BOSTON SCIENCE CENTER

FINAL PROJECT IMPACT
REPORT/(FPIR)

FINAL ENVIRONMENTAL
IMPACT REPORT/(FEIR)

EOEA NO. 7111R

Figure 6 - Proposed Project Site Plan

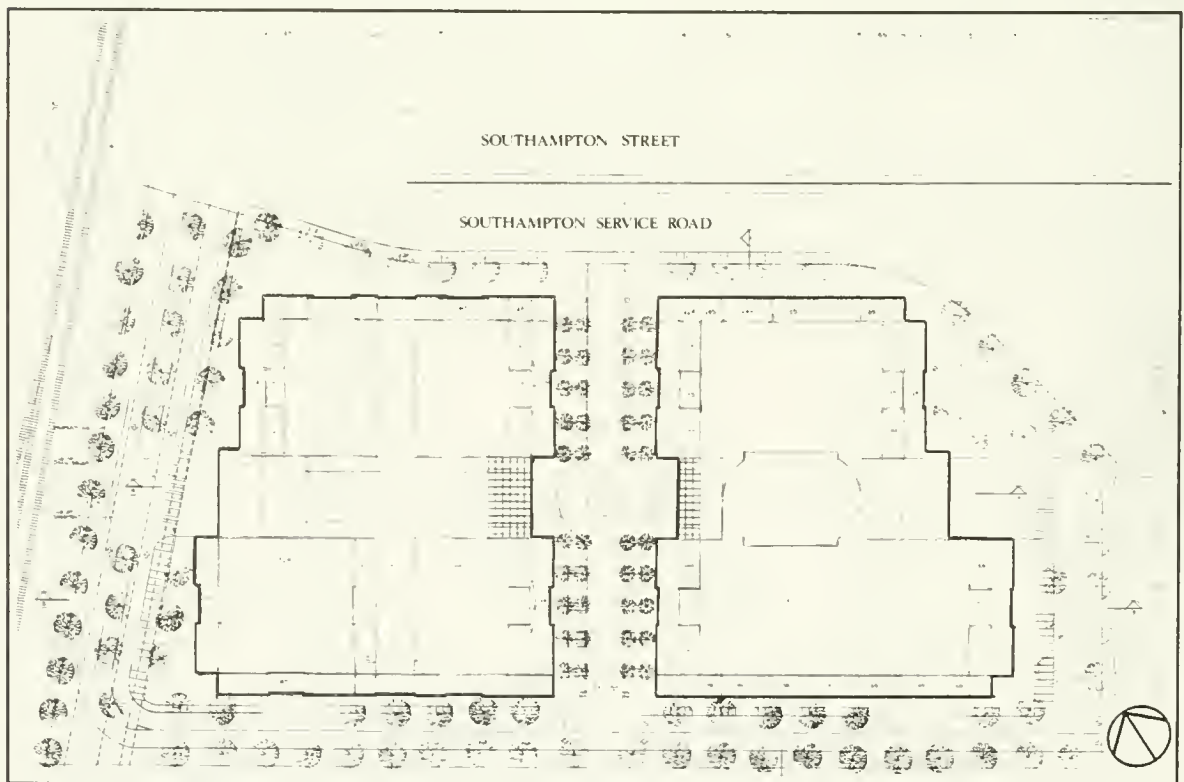
Provide continuous sidewalks around both buildings.

Sidewalks are being provided around both of the buildings (see Figure 6).

Figure 7 - Parking Plan : Basement Level (P-B)

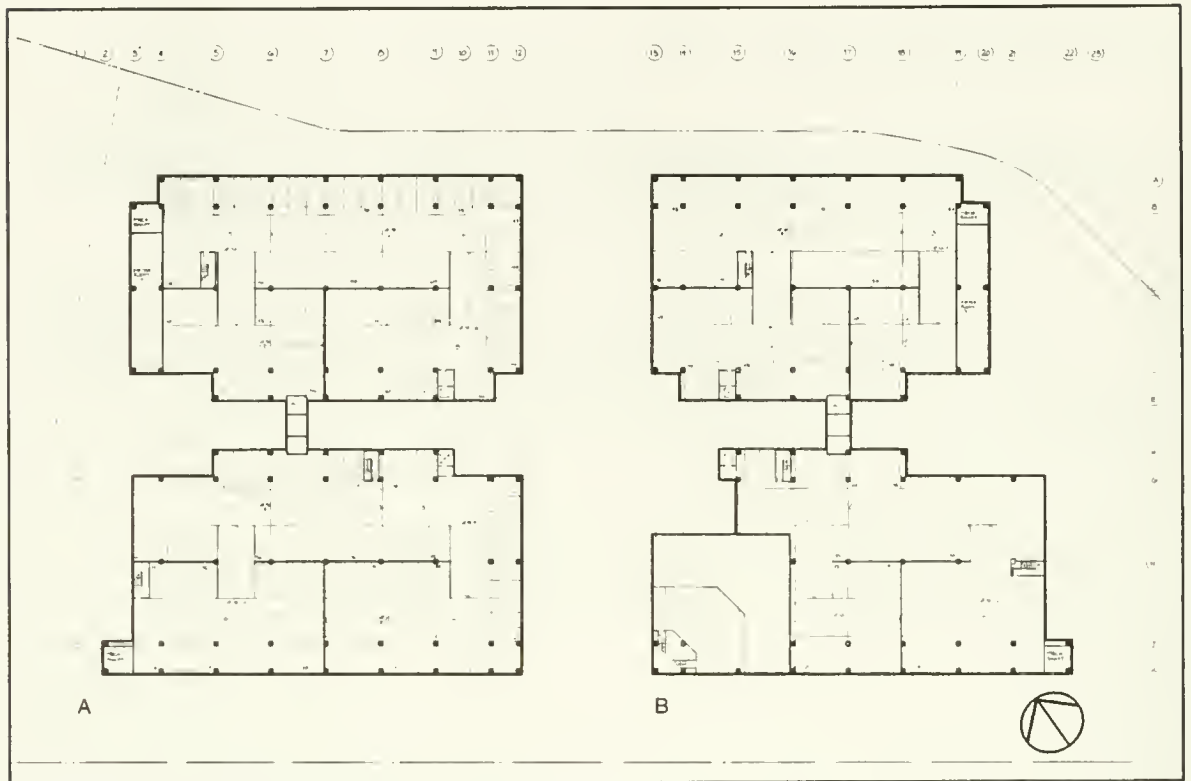
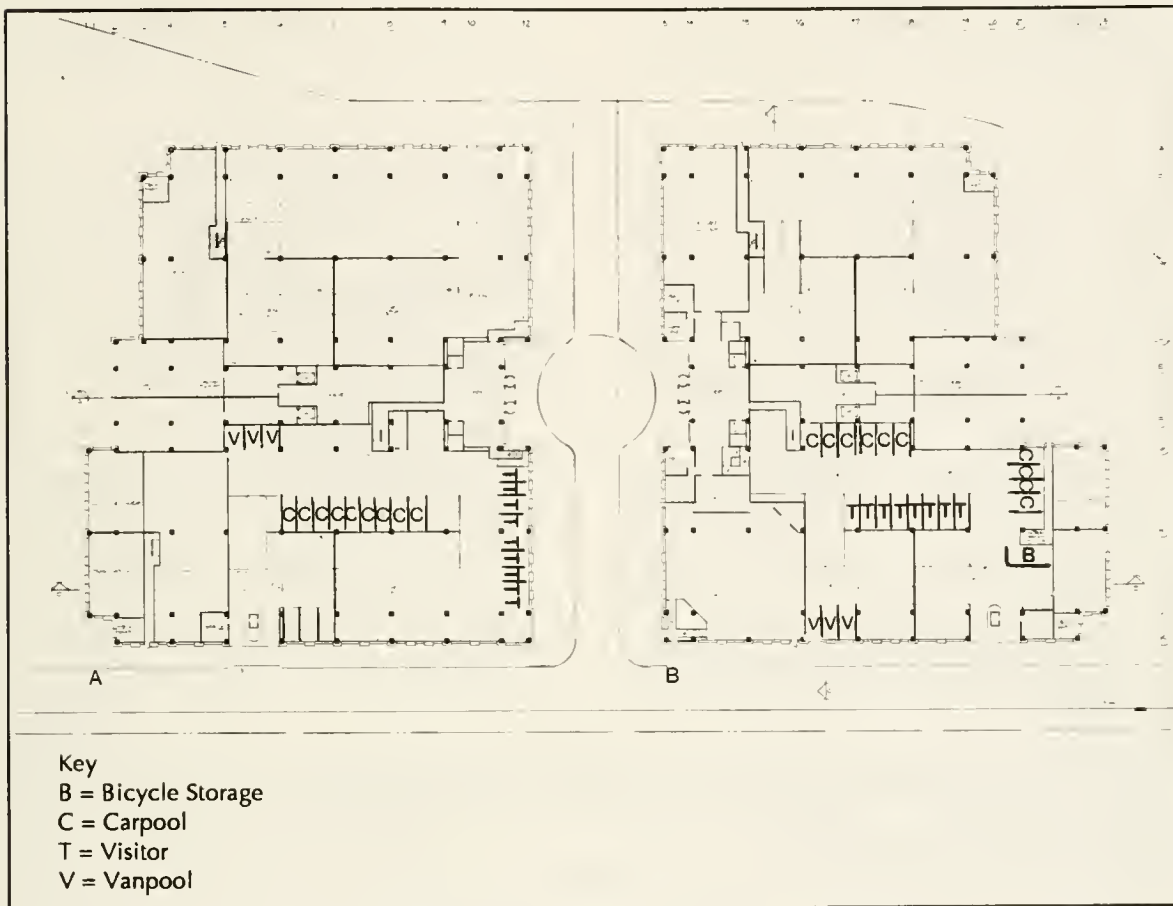
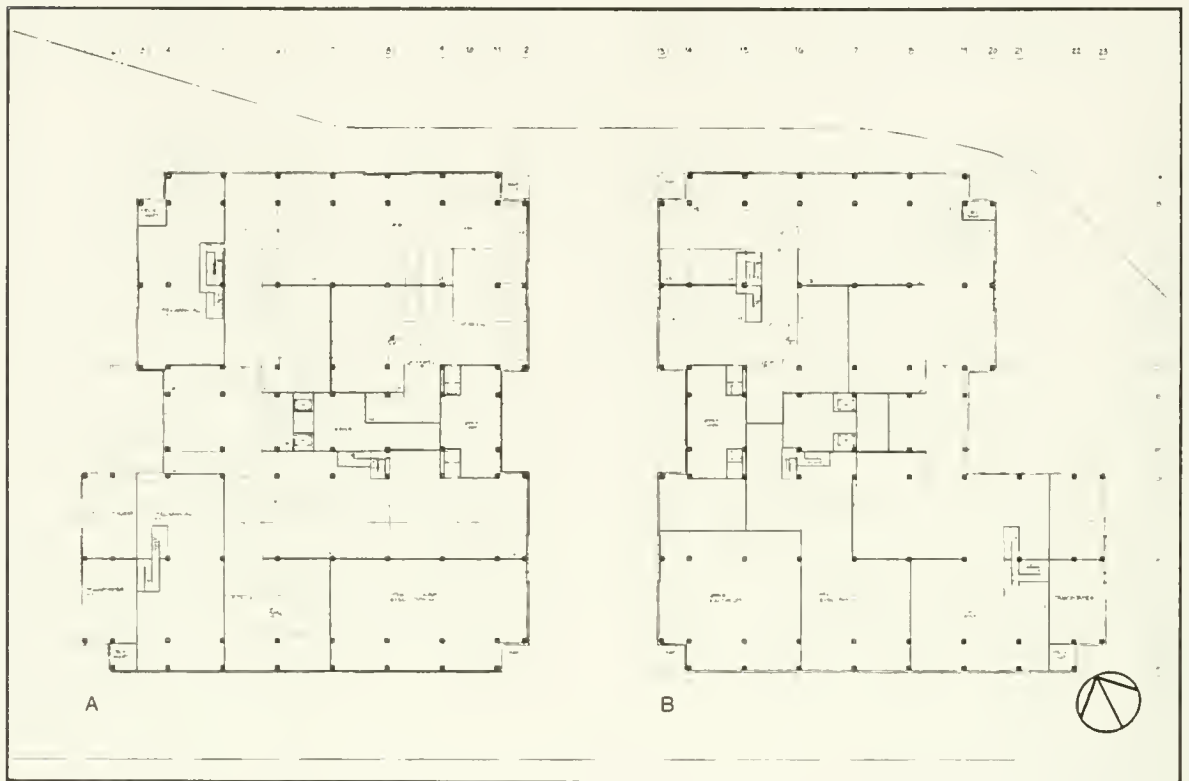
- 10 2. The FPIR must show which spaces are devoted to employees, which are devoted to visitors, and which are devoted to vanpools or the shuttle bus.

As shown on the parking plan shown in Figures 7-9, there are 19 spaces for visitors located on Level P-1 and 607 spaces for employees located on the three parking levels, of which 6 spaces are for van pools located on Level P-1; and 20 spaces for carpools located on Level P-1. The shuttle bus will be in continuous service from 7-10 AM and from 3-7 PM. During the midday when the shuttle service is operating on an as-needed basis, no storage will be needed because the bus must remain accessible. Overnight storage of the shuttle bus will be provided in the loading area.

Provide more information on the height and location of the garage exhaust vents.

The parking level at-grade consists of 40,050 sf of vehicle area in Building A and 33,025 sf of vehicle area in Building B for a total area of 73,075 sf (See Figure 8). Building A has capacity for 114 vehicles and Building B has capacity for 83 vehicles, for a total of 197 vehicles on this level. This level will be partially open to the outside. Natural ventilation has been proposed through punched ventilation grills in the walls of each structure. The open area is approximately 2,970 sf for Building A and 1,800 sf for Building B, totalling 4,770 sf for both P-1 levels. The entrance/exit points to each building are located on the south side of this level.

Figure 25 - Vehicular, Truck and Service Access

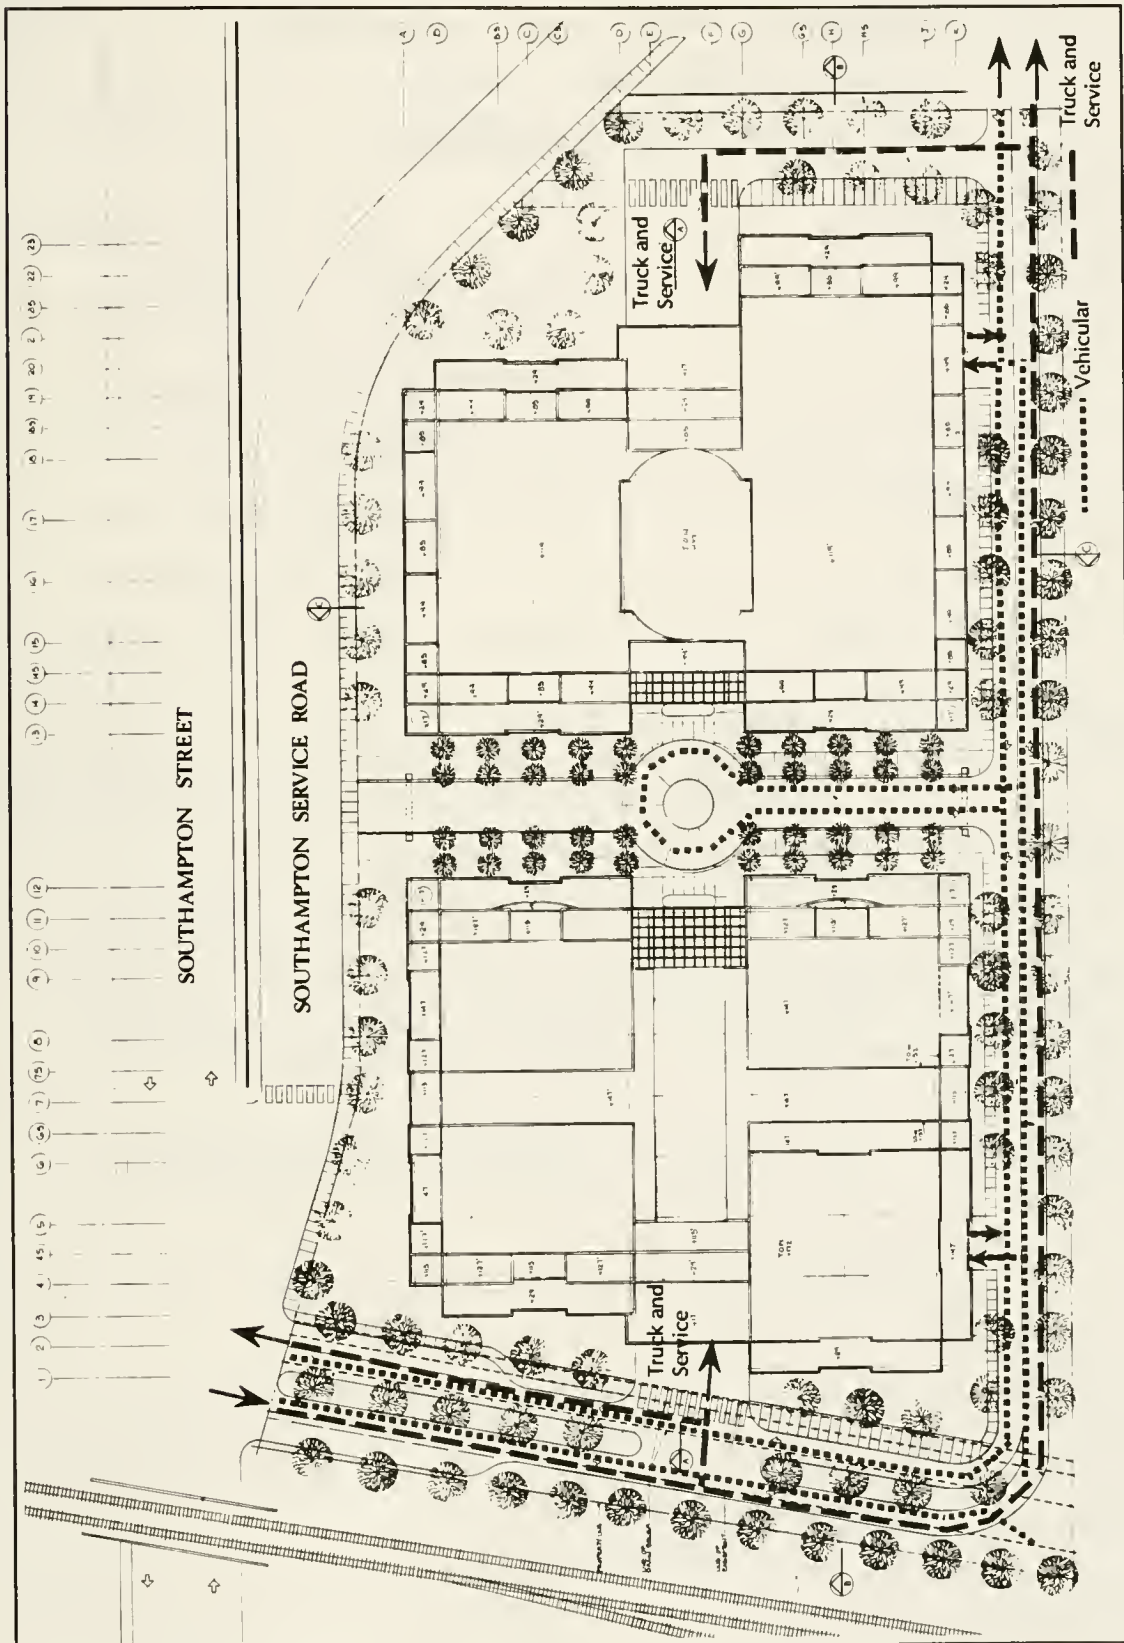
The site plan must be modified so that the function of roadways is not duplicated.

The internal circulation system has been revised from the one shown in the Draft EIR/PIR. As shown in Figure 25 of the revised project description, the internal site road no longer completely encircles the buildings. The internal circulation is via a two-way roadway beginning at the western site boundary on Southampton Street, continuing along the western site boundary and southern site boundary. Truck and vehicle circulation is along the same internal roadway with loading docks and parking garage access as shown. Feeding off this roadway is a cul-de-sac which will provide a drop-off location immediately in front of the building lobbies for visitors, handicapped persons, the shuttle bus and taxis.
